RESPONSE TO REQUEST FOR ADDITIONAL INFORMATION

APR1400 Design Certification

RAI No.: 25-7844
SRP Section: 06.02.02 - Containment Heat Removal Systems
Application Section: 6.2.2
Date of RAI Issued: 06/11/2015

Figure 1 Sparger Locations within the IRWST

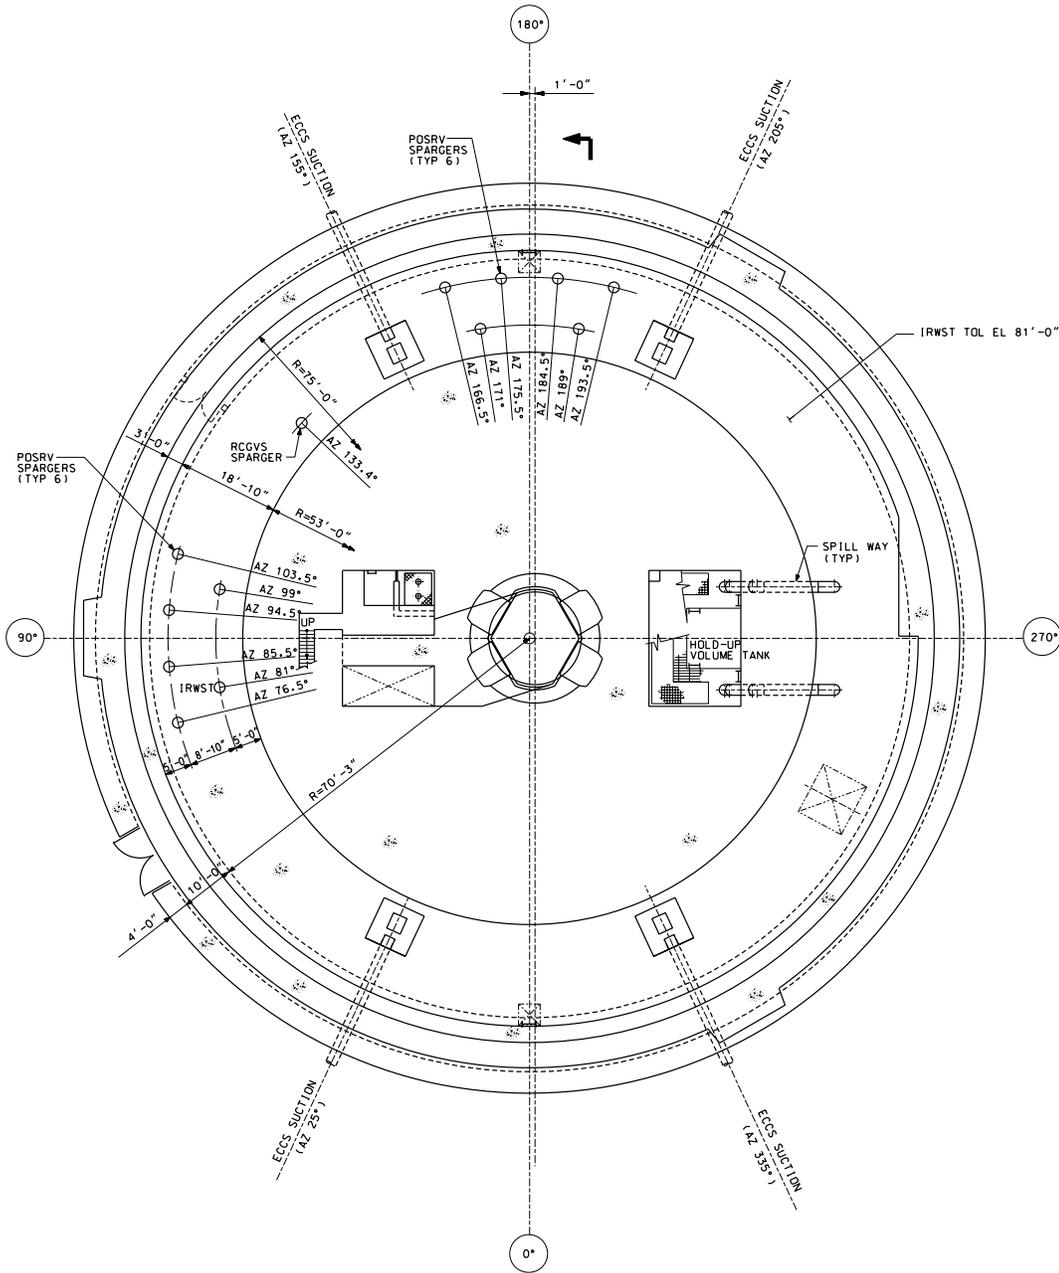
- A. The spargers do not appear in any of the line diagrams in relation to the rest of the IRWST. Update the design control document (DCD) to include the spargers and associated piping within the IRWST, particularly with respect to their elevation and spatial relationship to the strainers. The staff needs this information in order to have a full understanding of the system to make a safety finding that the system will function under all postulated accident conditions.

To identify the spatial relationship of the spargers to the strainers located on the IRWST sump, sparger locations in the IRWST are provided in Figure 1. The IRWST and HVT plan view in DCD Figure 6.8-1 will be replaced with Figure 1, as shown in Attachment 3, to show the RCGVS and POSRV spargers.

Figure 2. Typical header piping and spargers in IRWST

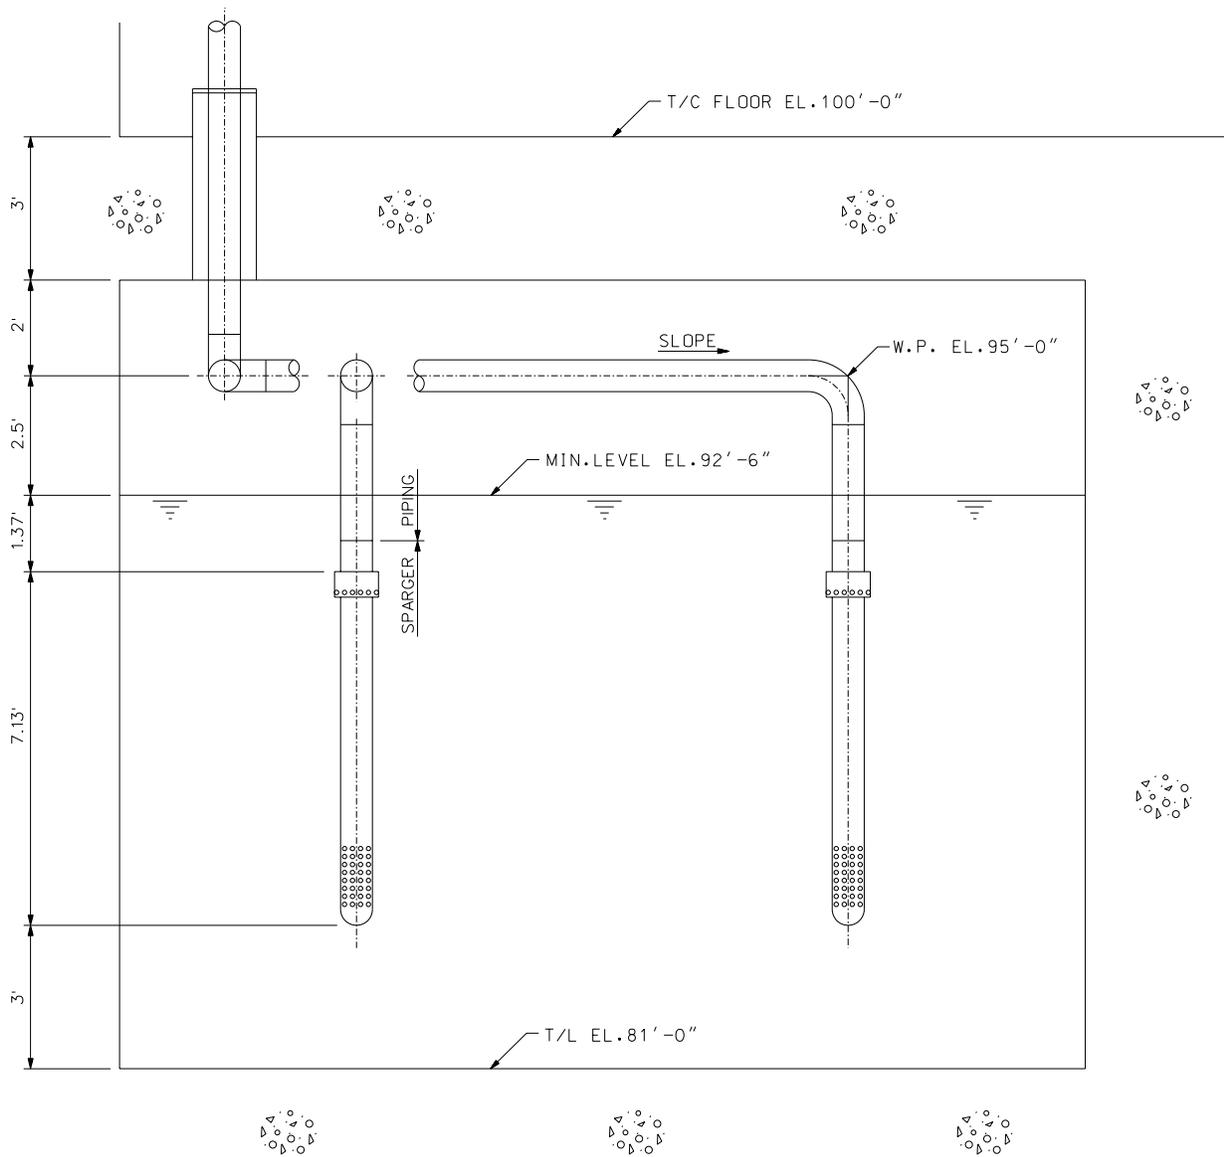
- B. The effect of steam release from the spargers while submerged is discussed in the DCD; however, the effect of fluid release from the spargers while not fully submerged is not explored. Are there any postulated accidents (for example, involving feed and bleed or release from the reactor head vent) where the spargers are uncovered or partially uncovered during release? If so, discuss and explain in detail in the DCD the effects of uncovered release from the spargers on the spargers themselves, the IRWST, and associated structures.

The typical arrangement of header piping and spargers in the IRWST is provided in Figure 2 and will be included in the DCD as Figure 6.8-7. Proposed Figure 6.8-7, "Typical Header Piping and Sparger in IRWST" is included in this response as Attachment 4.

In the APR1400, there are no postulated accidents that cause the sparger holes to be uncovered above the IRWST pool surface during steam release through the POSRVs. Figure 2 shows that the top most holes of the spargers are submerged 1' 4.4"(1.37') below the minimum water level of the IRWST.

Figure 1. Drop size spectrum for main spray nozzle

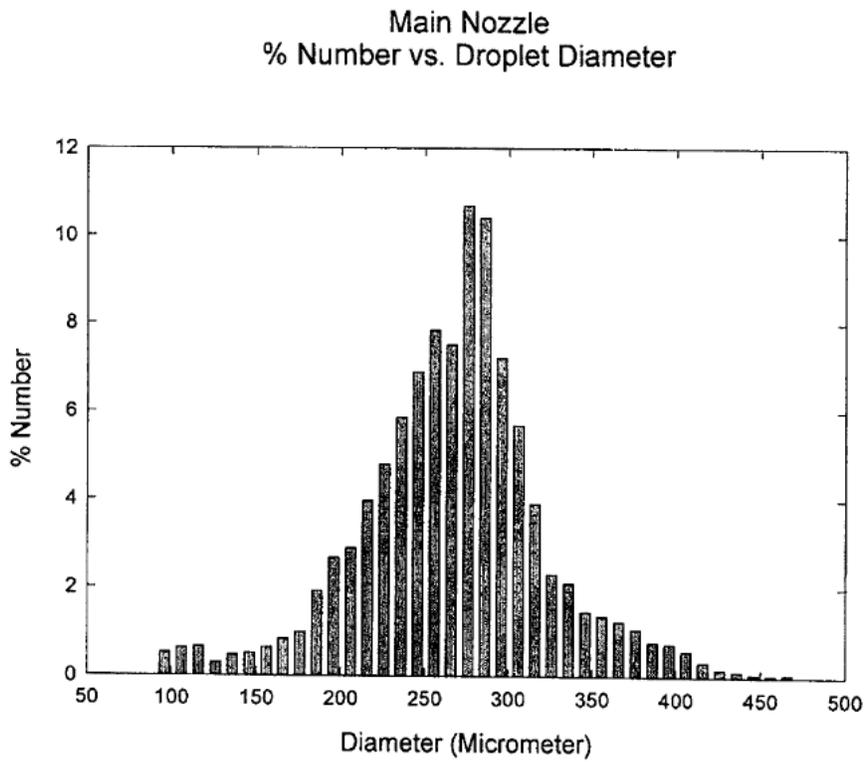
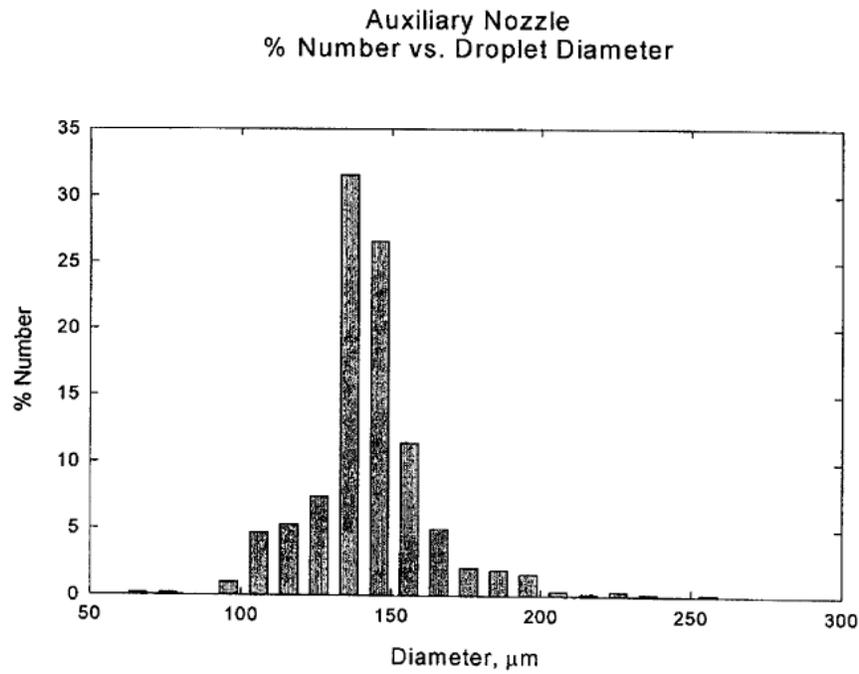
SRP section 6.2.2 stipulates that the spray drop size spectrum as a function of pressure be provided in order to provide the staff reasonable assurance that the test program for the spray nozzles shows the droplets to reasonably be bounded by the values specified in the DCD. Although a mean droplet size as a function of pressure and a maximum droplet size to be used in analyses is specified, no such spectrum of drop sizes is identified. Provide, in the DCD, the range of droplet sizes produced by the spray nozzles.

The drop size spectrums for the main spray nozzles and auxiliary spray nozzles produced at the nozzle design condition of 2.81 kg/cm²D(40 psid) are shown in Figure 1 and 2, respectively. These spectrums were obtained by testing as described in DCD Section 6.2.2.4. The testing was conducted by the SVC Inc. in Korea.

The main spray nozzle drop size ranges from 90 microns to 490 microns, and the auxiliary spray nozzle drop size ranges from 60 microns to 260 microns, at the nozzle design condition of 2.81 kg/cm²D (40 psid).

Figure 1. CS heat exchanger Modeling for Containment P/T analysis

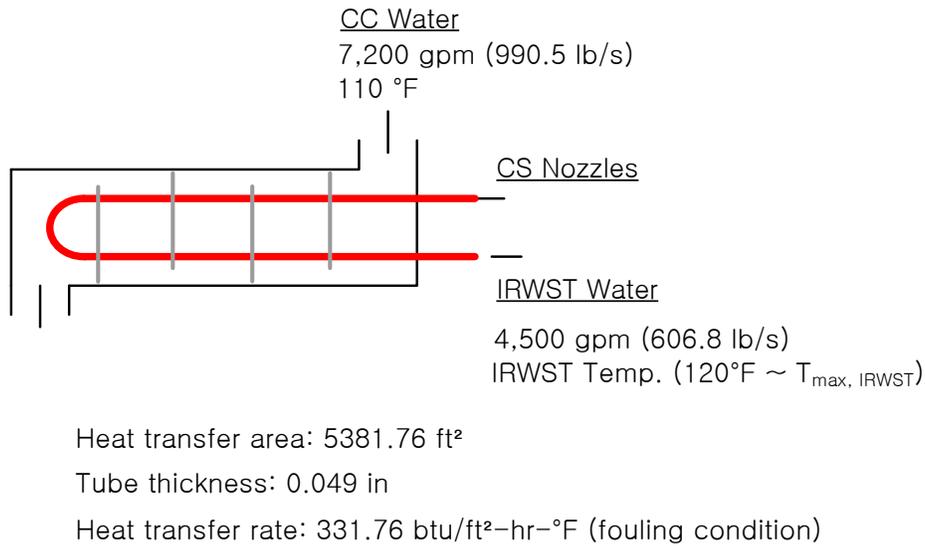
1. SRP section 6.2.2 states that a discussion on the surface fouling used for heat exchangers used to assure containment heat removal capability shall be provided. While the design control document (DCD) references a fouling value for the containment spray (CS) heat exchangers, no such discussion is provided. In the DCD, describe how the value provided in Table 6.2.2-2 is arrived at, including whether the value bounds the fouling values expected over the life of the plant.
2. In a response, describe how the CS heat exchangers are modeled in the analyses presented in Section 6.2 of the DCD. The staff requires this information to complete the following:
 - make a safety finding that the heat exchangers will perform their function over the life of the plant
 - perform a confirmatory analysis

- The CS heat exchanger used for the APR1400 containment P/T analysis is modeled using a GOTHIC heat exchanger component. The CS heat exchanger model uses a design heat transfer coefficient (UA) and CS heat exchanger input data which are developed from the design specification sheets, summarized in Table 1. Figure 1 shows the schematic diagram of the CS heat exchanger modeled in the GOTHIC containment analysis.
